Intersection ID: 10936	Main Street: LITTLE_ROCK_RD	Cross Street: SCOTT_FUTRELL_DR	Location:	SW
ADA ID: EC1067FCC674	Ramp Type: Para	Initial Pass/Fail: Fail	Overall Compliance: No	Severity Score: 12.5

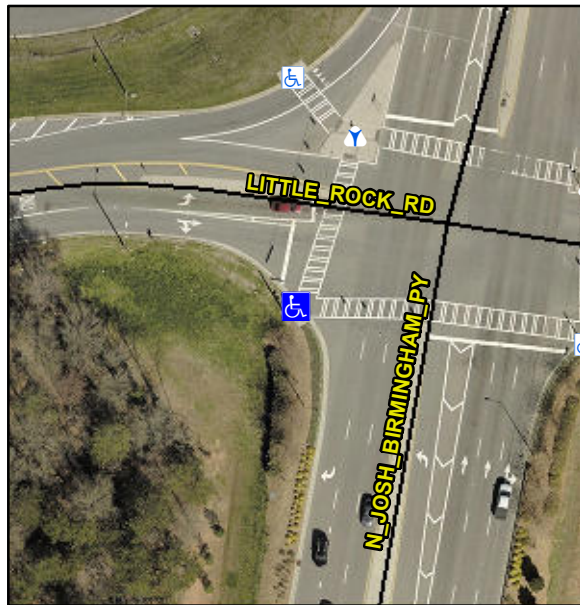
LT RP < 5%

R304.3.2

Remove & Replace Entire Ramp.
